**Re: FortisBC Energy Inc. (FEI)**

**Application for a Certificate of Public Convenience and Necessity (CPCN) for  
Approval of the Lower Mainland Intermediate Pressure (IP) System Upgrade  
(LMIPSU) Projects (the Application)**

**Response to the British Columbia Utilities Commission (BCUC or the  
Commission) Information Request (IR) No. 1**

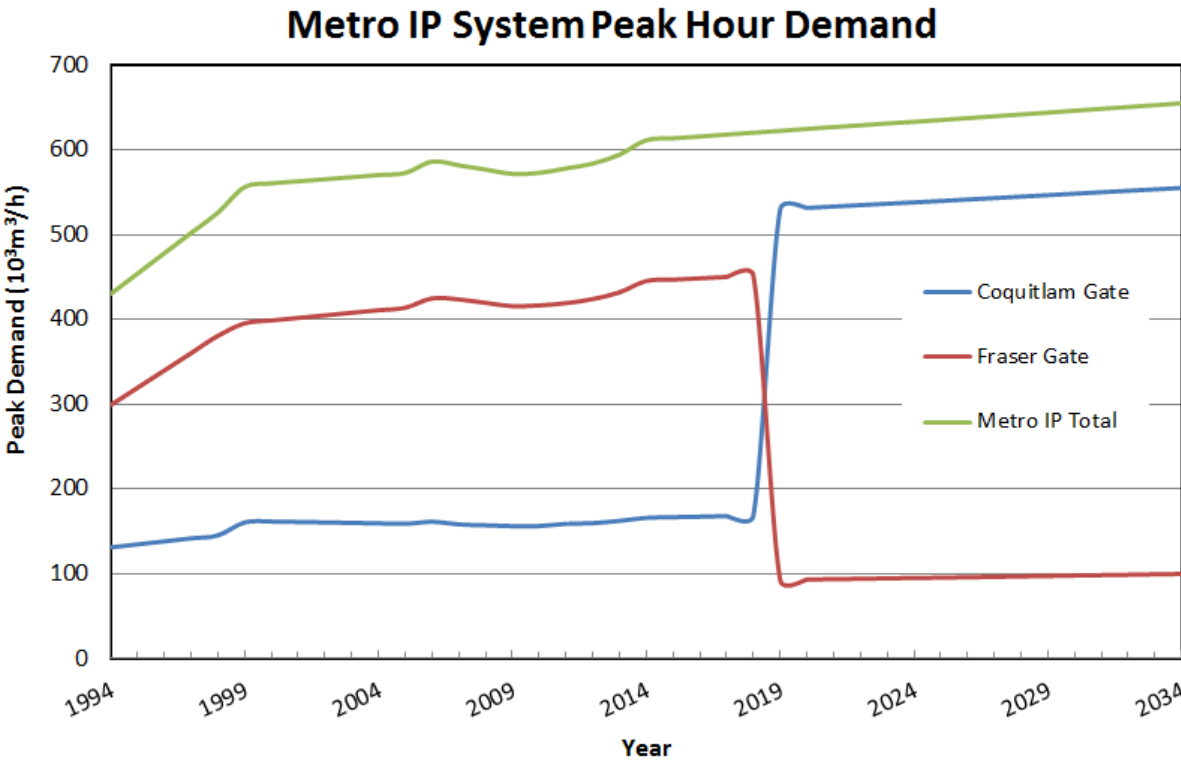
3.3 Please provide graphs of the historical and forecasted design degree day load (i.e. peak demand) on the Metro IP system supplied by the existing Coquitlam IP pipeline, existing Fraser Gate IP pipeline, replaced Coquitlam IP Pipeline and replaced Fraser Gate IP pipeline from 1994 to the end of the 20-year planning period.

The graph below illustrates the change in peak hour demand, as determined by a review of available historical records, for the design peak hour demand through Coquitlam Gate and Fraser Gate into the Metro IP system. In some case the historical information was unavailable to be plotted. Where this occurred, values were interpolated from years where the data was available. For example, information for 1996 and 1997 was unavailable and was interpolated from data available in the historical record from 1995 and 1998. Values for future years reflect the 2014 load forecast. The load shift between Coquitlam Gate and Fraser Gate in 2019 reflects the commissioning of the proposed NPS 30 Coquitlam Gate IP pipeline at which point the larger part of the Metro IP system will be supported through Coquitlam Gate under normal circumstances.

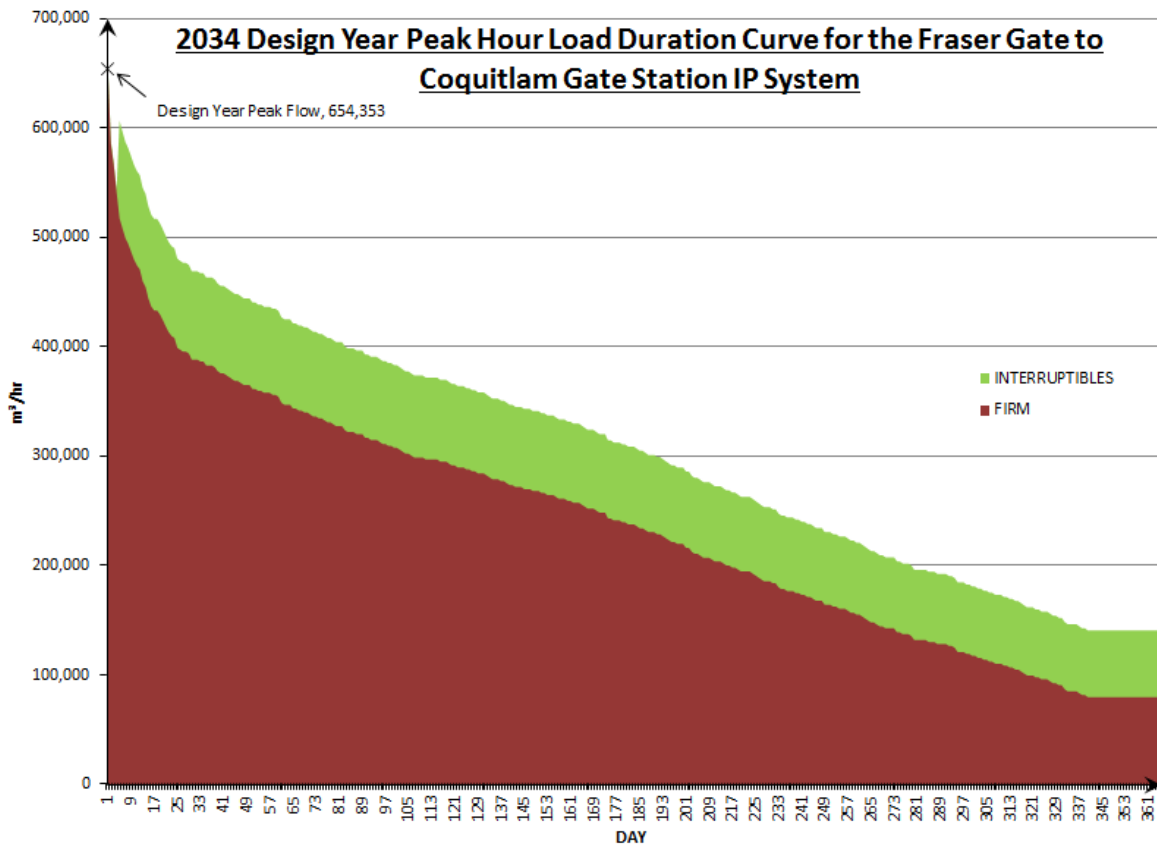
6.7 Please provide a Load Duration Curve for the Fraser Gate station to Coquitlam Gate station IP system now and at the end of the 20-year planning period, which shows the expected daily or hourly loads for each day of a design year.

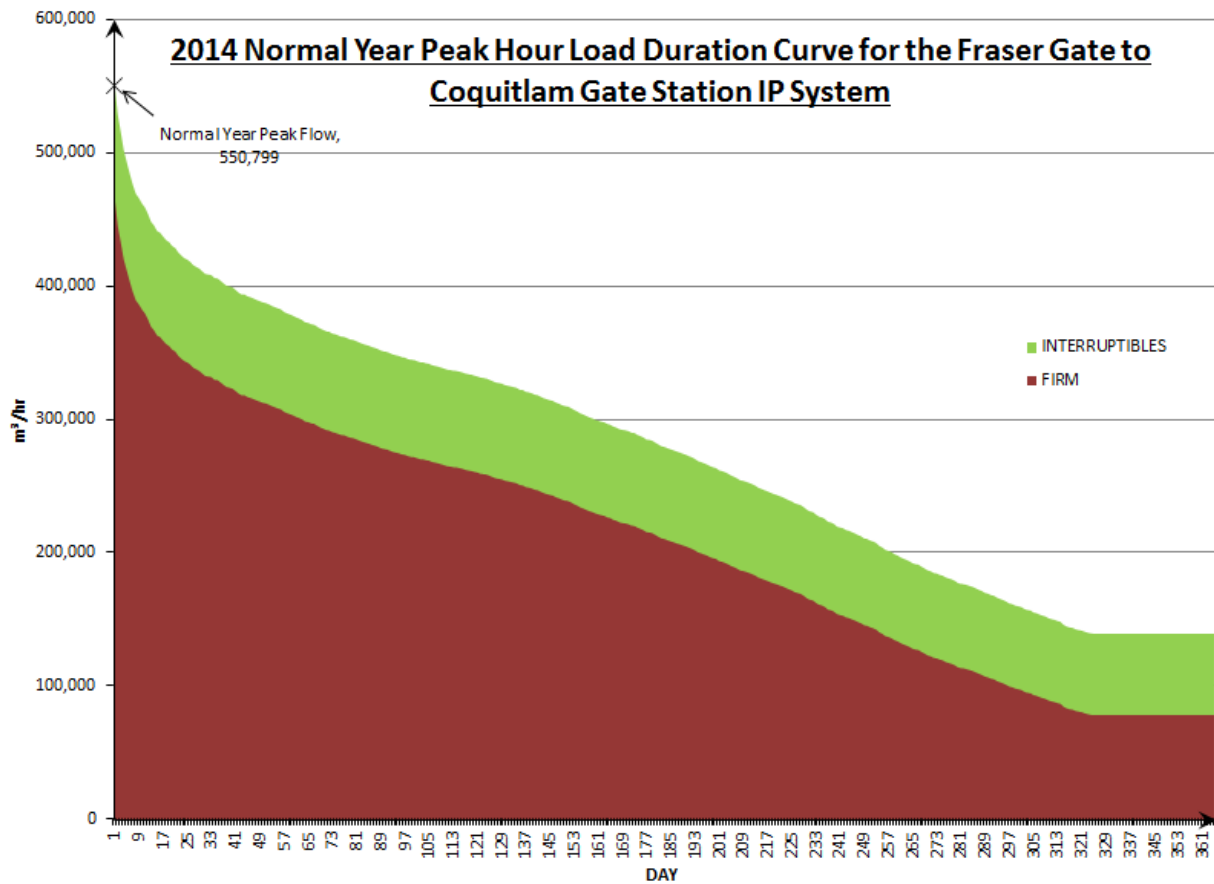
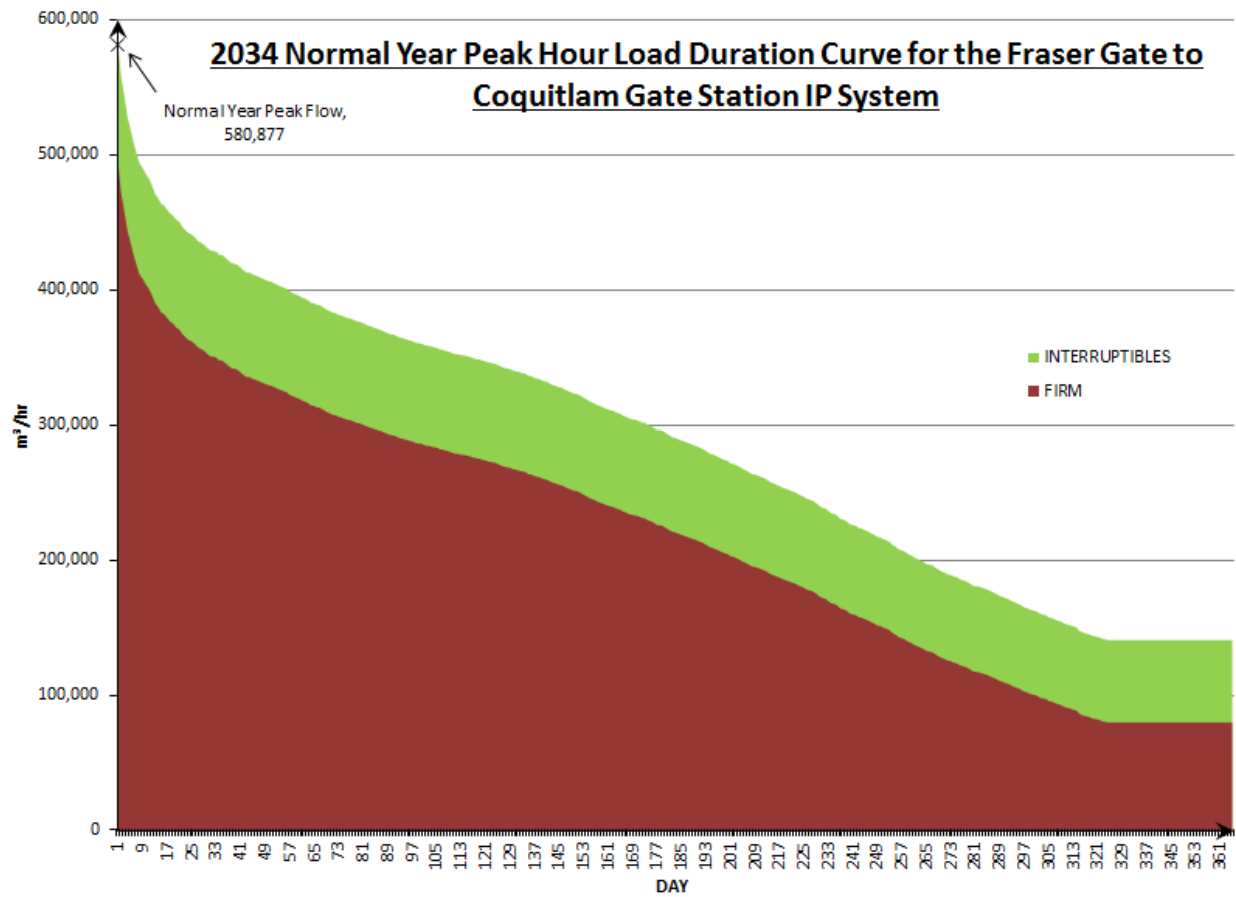
6.8 Please provide a Load Duration Curve for the Fraser Gate station to Coquitlam Gate station IP systems now and at the end of the 20-year planning period, which shows the expected daily or hourly loads for each day of an average year.

The requested Normal Year Load Duration Curves are provided below. Interruptible rate classes are shown as the peak hour demand with interruptible demand does not exceed design peak capacity in a normal year.
